ANADROMOUS WATERS CATALOG/ATLAS
CORRECTION FORM

MAP: AQAK B-3

WATERWAY NUMBER: 306-20-12550 and 12550-0010

NOMINATION NUMBER: 95-044

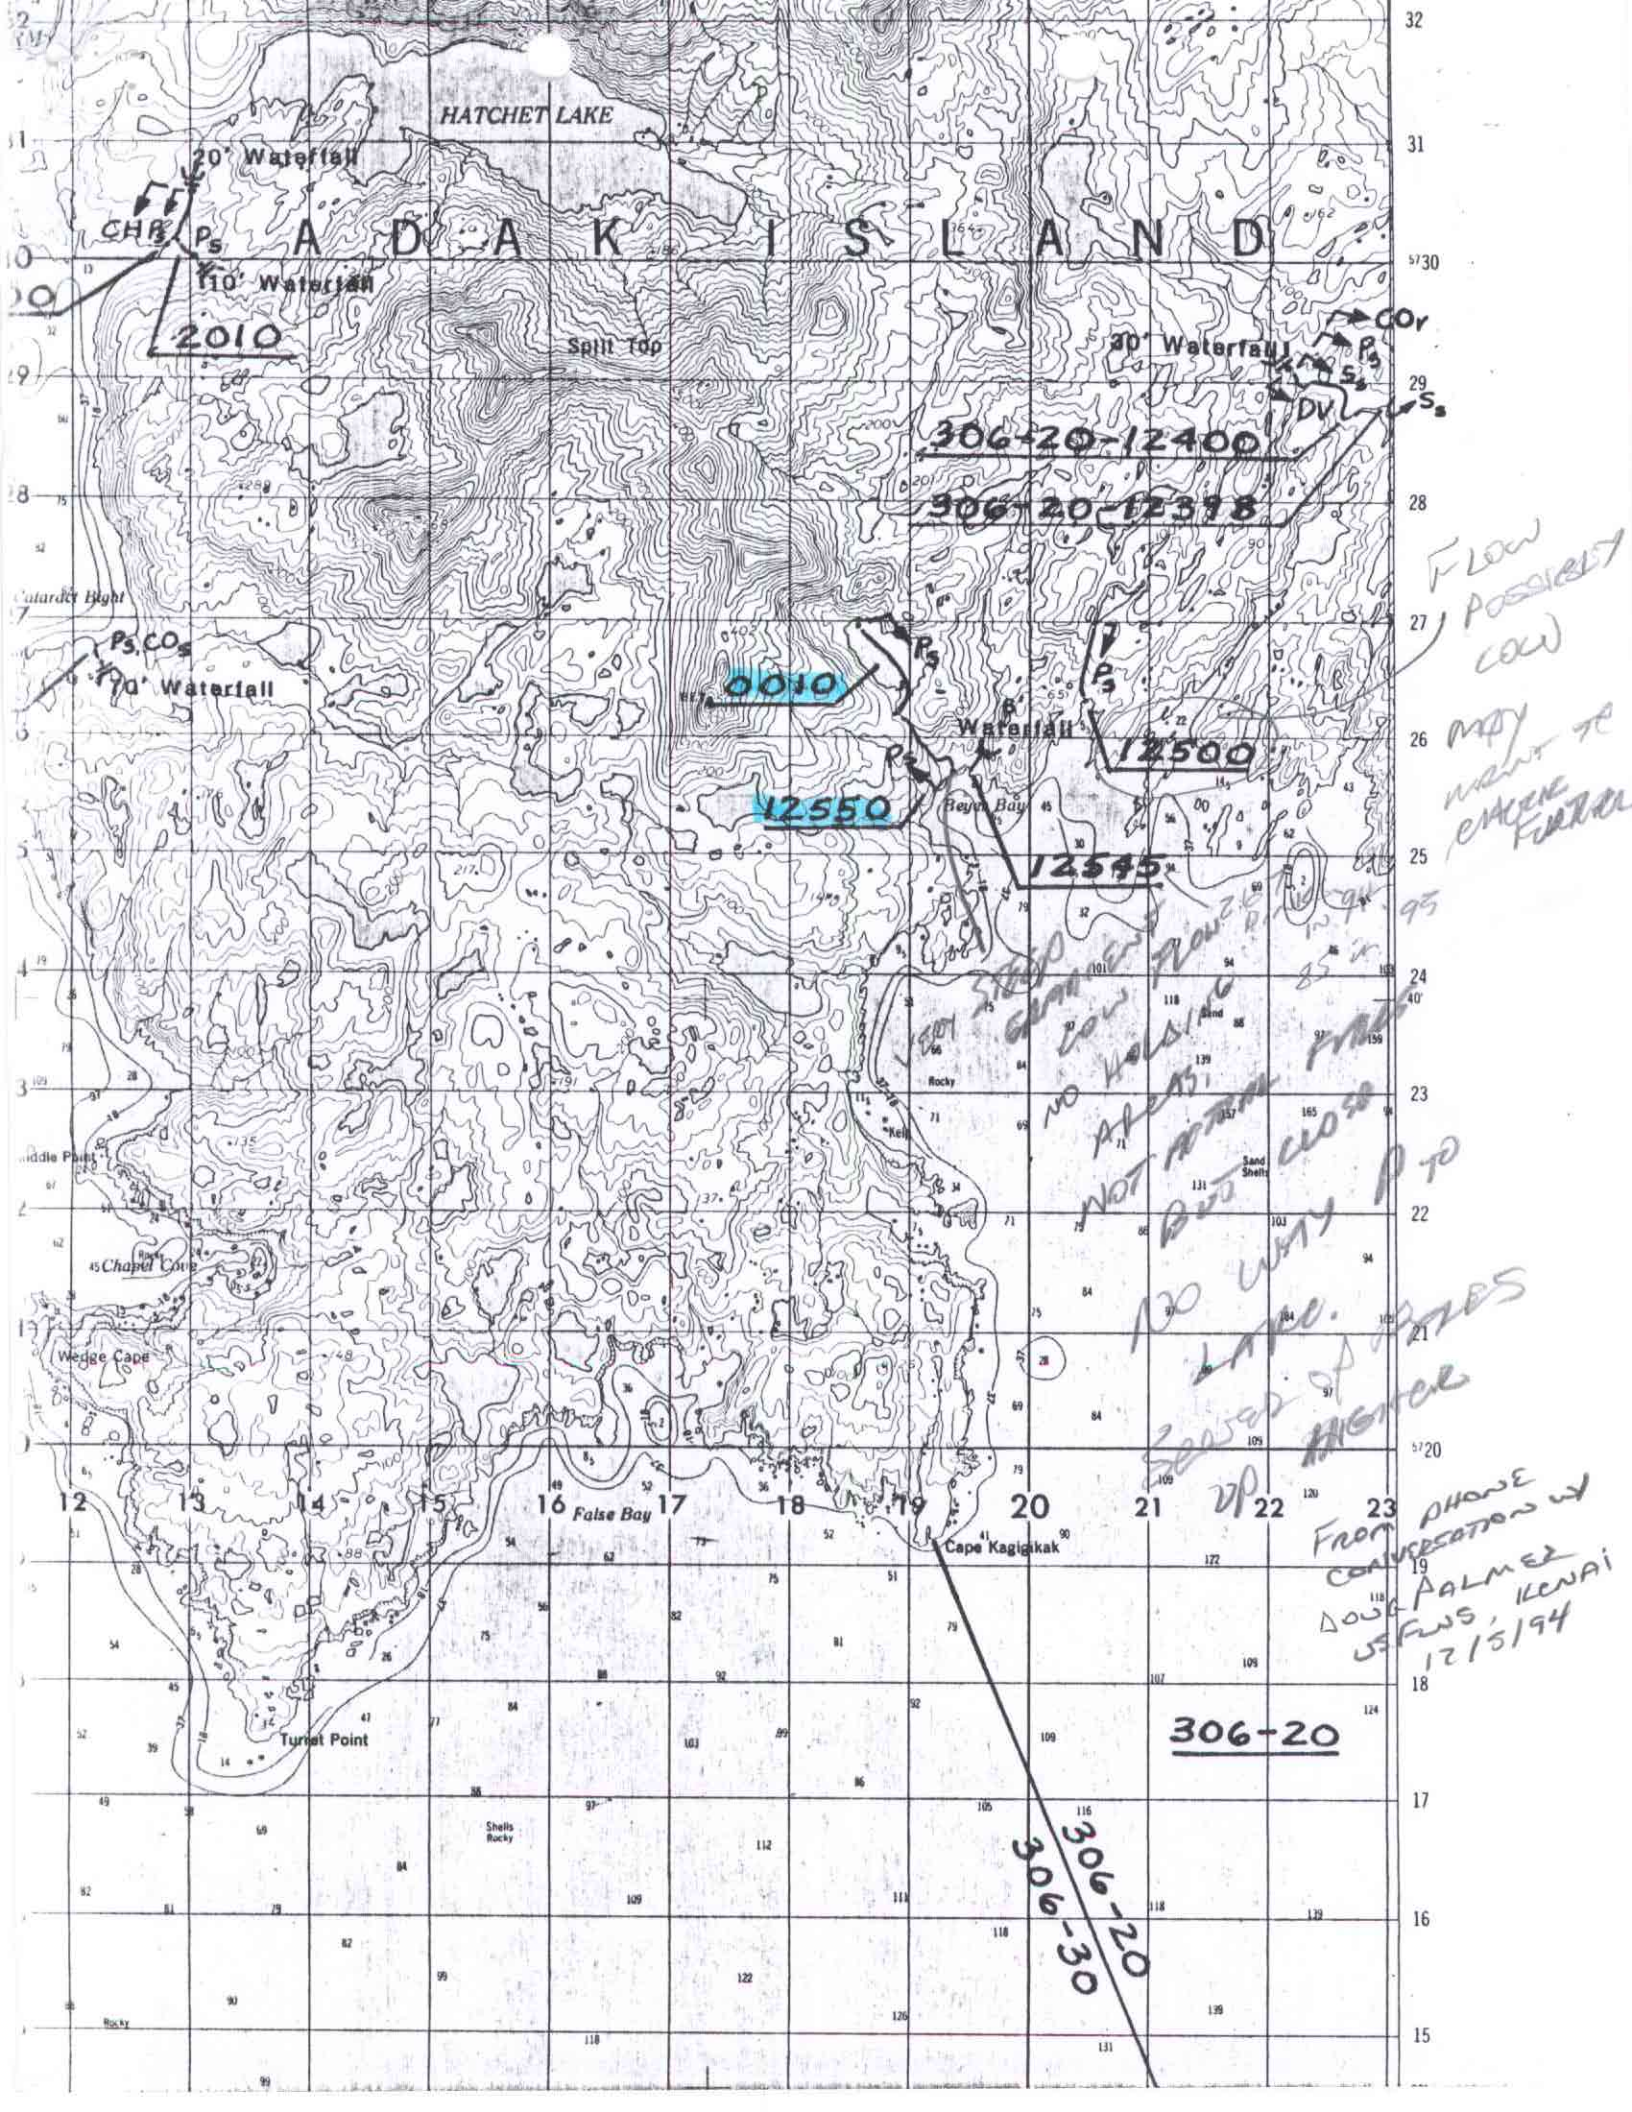
DESCRIBE CHANGE(S): DELETE STREAM. AS CURRENTLY CATALOGED THIS STREAM IS IMPASSABLE. ORIGINAL NOMINATION, (GALLIS, HOLMES 1983) PUTS LOCATION .8 mi WEST OF THIS LOCATION. THIS COULD NOT BE CONFIRMED IN CONVERSATIONS W/ PAT HOLMES. DELETE PENDING FURTHER INFORMATION.

Comments: The barrier for this stream is at the Ocean. It is not possible for salmon to enter this stream or make the trip into the Lake (306-20-12550-0010).

HATCHET LAKE
20' Waterfall
CHP
Ps
A D A K I S L A N D
110' Waterfall
2010
Split Top
30' Waterfall
COr
Ps
Ss
DV
Ss
306-20-12400
306-20-12398
Cataract Bight
Ps, COs
70' Waterfall
0010
Ps
Ps
6' Waterfall
12500
12550
Beyer Bay
12545
Middle Point
Chapel Cove
Wedge Cape
False Bay
Cape Kagigikak
Turret Point
Shells Rocky
Rocky
Sand
Sand Shells
12
13
14
15
16
17
18
19
20
21
22
23
306-20
306-20
306-30
FLOW POSSIBLY LOW
MAY WANT TO CHECK FURTHER
VERY STEEP GRADIENT LOW FLOW 2.6 in 94 85 in 95
NO HOLDING AREAS, NOT ACTUAL FORCES BUT CLOSE
NO WAY P TO LAKE.
SEEVED UP TO HIGHER
FROM PHONE CONVERSATION W/ DOUG PALMER USFWS, KENAI 12/5/94
